# ADDENDUM

Project Name: Baker Elementary Science Lab Renovations Addendum No.: **One (1)**  
Canadian ISD Date: 12/04/08  
723 Cheyenne Ave. Project No.: 07008.7  
Canadian, Texas 79014-3233

SUPPLEMENTAL DRAWING NO. SD-1

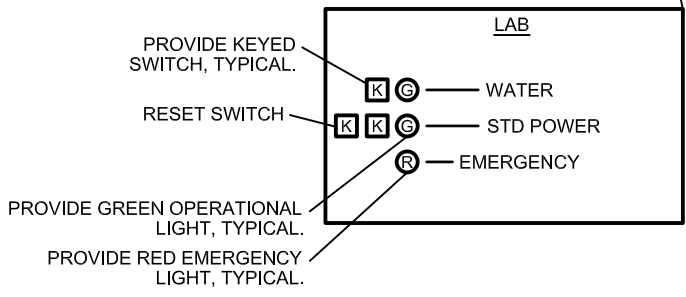
- Item No. One:** In the Specifications, Section 11600 – Laboratory Equipment, for clarification purposes there shall be **NO** gas service provided in the Lab Area. The gas service called for at the Teacher's Demonstration Desk and the Exhaust Hood shall be omitted. Provide all other equipment as called for on the plans.
- Item No. Two:** In the Drawings, Sheet P1 – Riser Diagram, provide riser diagram for solenoid valve at emergency cut-off for water as shown in Supplemental Drawing SD-1 attached herewith.

PROVIDE CONTACTOR ENCLOSURES WITH KEYED SWITCHES IN THE FACE OF THE ENCLOSURE. PROVIDE HINGED FRONT COVER. ARRANGE LIGHTS AND SWITCHES AS SHOWN. PROVIDE ENGRAVED LABELS AS SHOWN. TYPICAL FOR EACH LAB.
